**IFB 23-042UM-TG
Lift Station 7 Replacement Project REBID**

Addendum No. 4

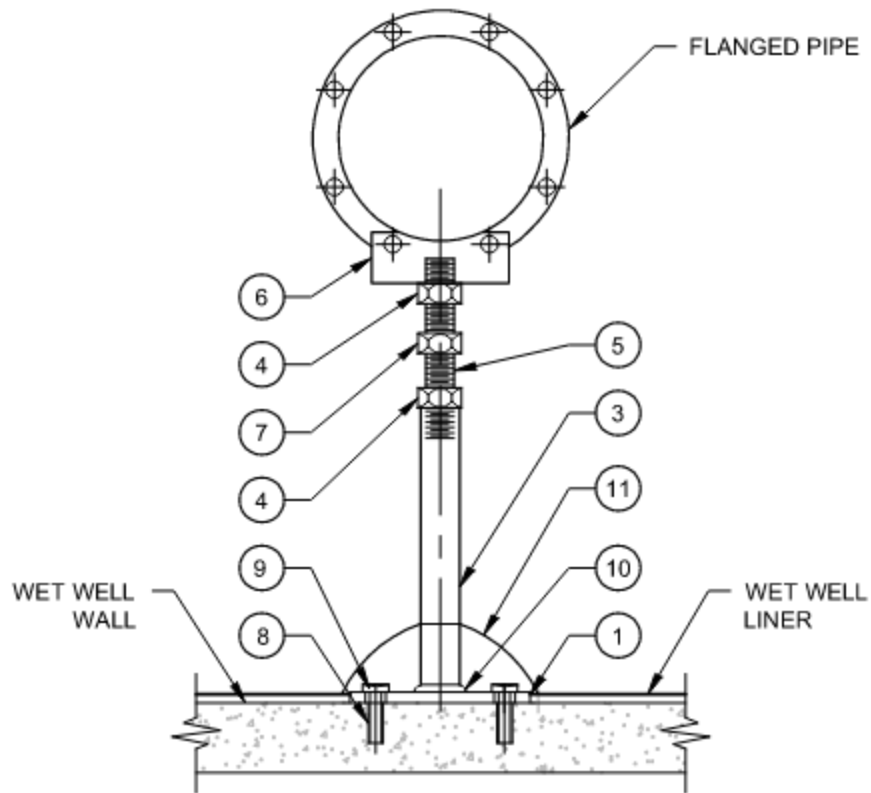
27. Please confirm the pressure gauge detail, plan sheet 10 calls for a ½" ss ball valve for the pressure gauge but the detail calls for a ¼" tap.

- a. What size tap is required on the Flanged T that requires a pressure gauge assembly?
- b. There are two pressure gauge assemblies provided in the plans, please confirm which detail is required.

Response: Use Pressure Gauge Assembly Detail on Pump Station Site Sheet No. 11 with a ½" tap.
